ORIGINATION FORM

Proposed Revisions to a Standard Plans Index (Please provide all information — Incomplete forms will be returned)

Index Number: 455-054

Index Title: 54" Square Precast/Post-Tensioned Concrete
Cylinder Pile**Summary of the changes:**

ELEVATION

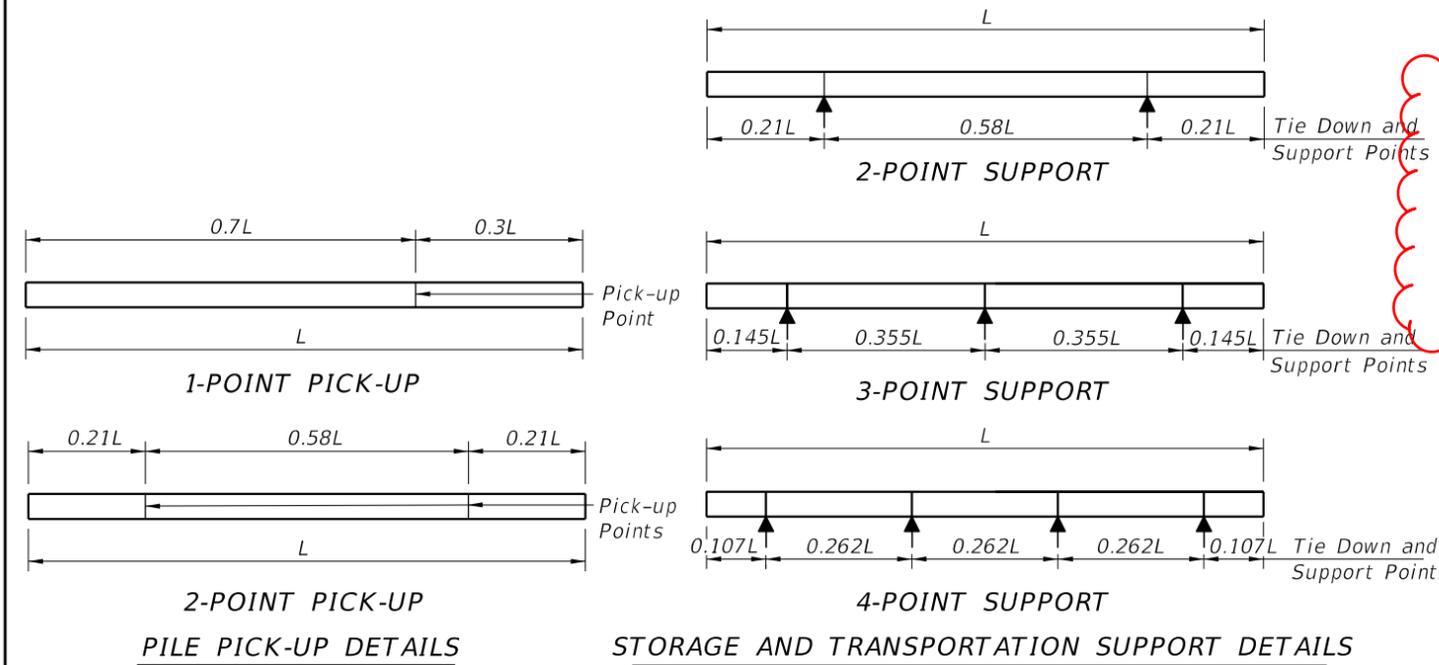
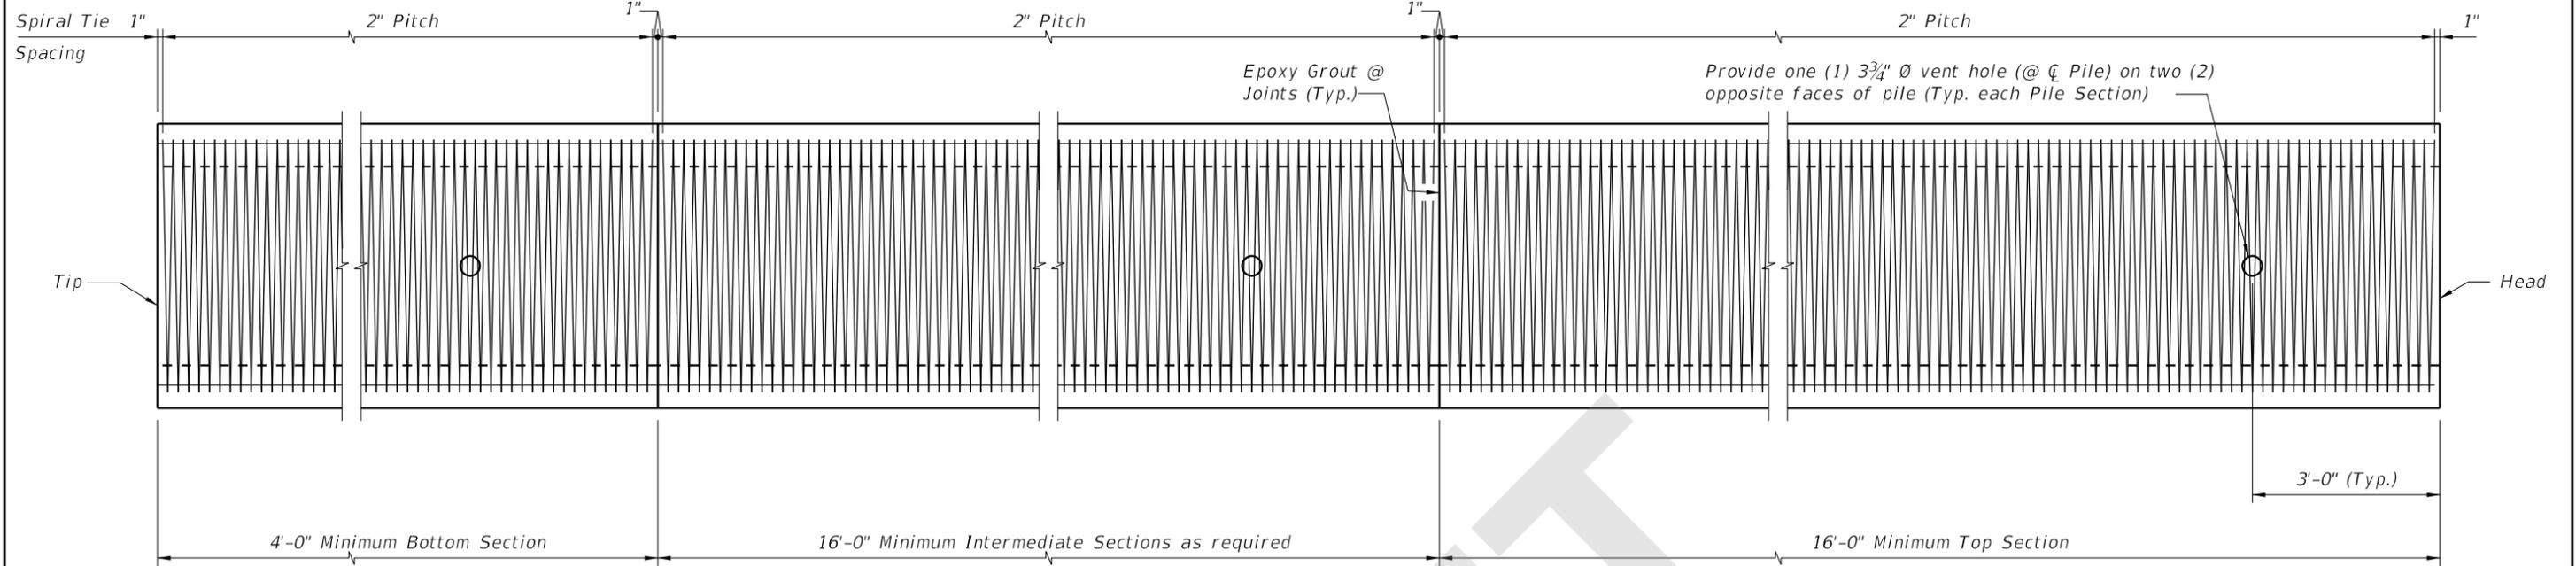
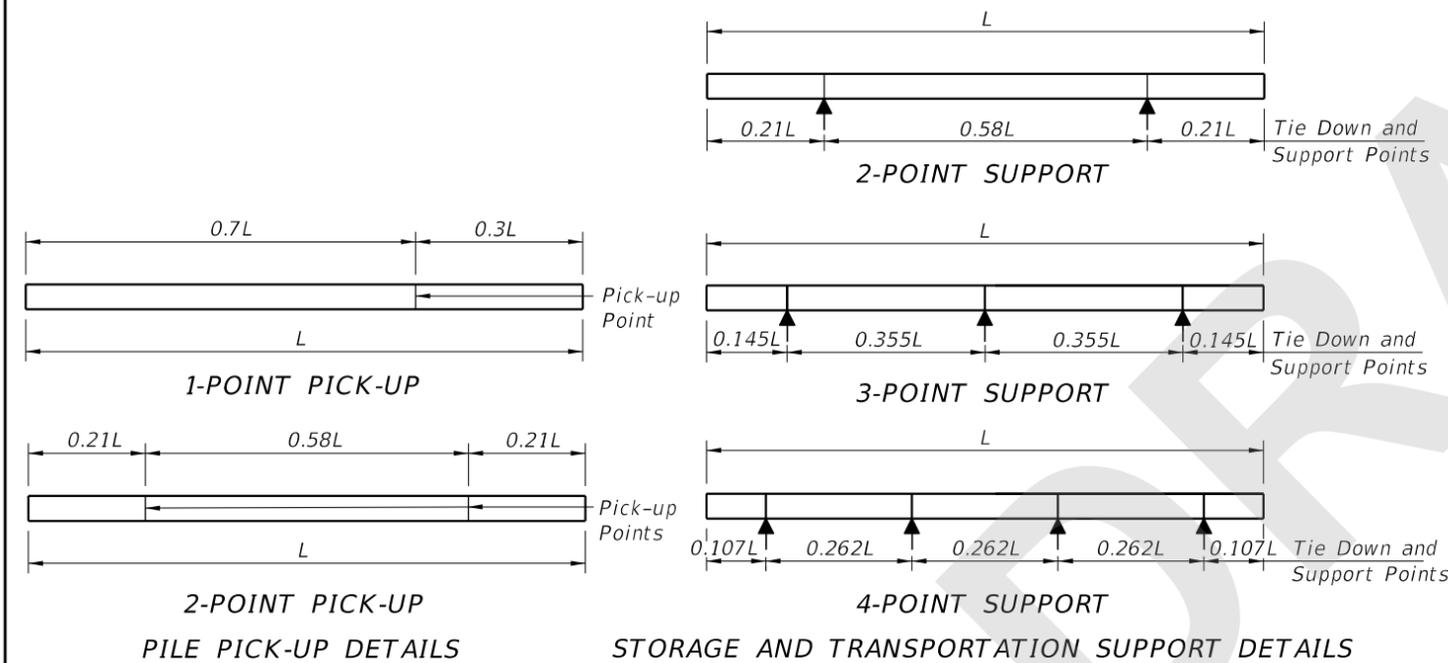
Change Silica Fume, metakaolin or ultra-fine flyash to Highly Reactive Pozzolans

Specification changed to fit silica fume, metakaolin and ultra-fine flyash under Highly Reactive Pozzolans

- Work this Index with the Pile Data Table in the Structures Plans.
- Concrete:
 - Piles: Class V (Special).
 - Splice: Class IV.
 - ~~Silica Fume~~: See "GENERAL NOTES" in Structures Plans for locations where the use of silica fume, metakaolin or ultra-fine flyash is required.

Highly Reactive Pozzolans

- Work this Index with the Pile Data Table in the Structures Plans.
- Concrete:
 - Piles: Class V (Special).
 - Splice: Class IV.
 - See "GENERAL NOTES" in Structures Plans for locations where the use of Highly Reactive Pozzolans is required.
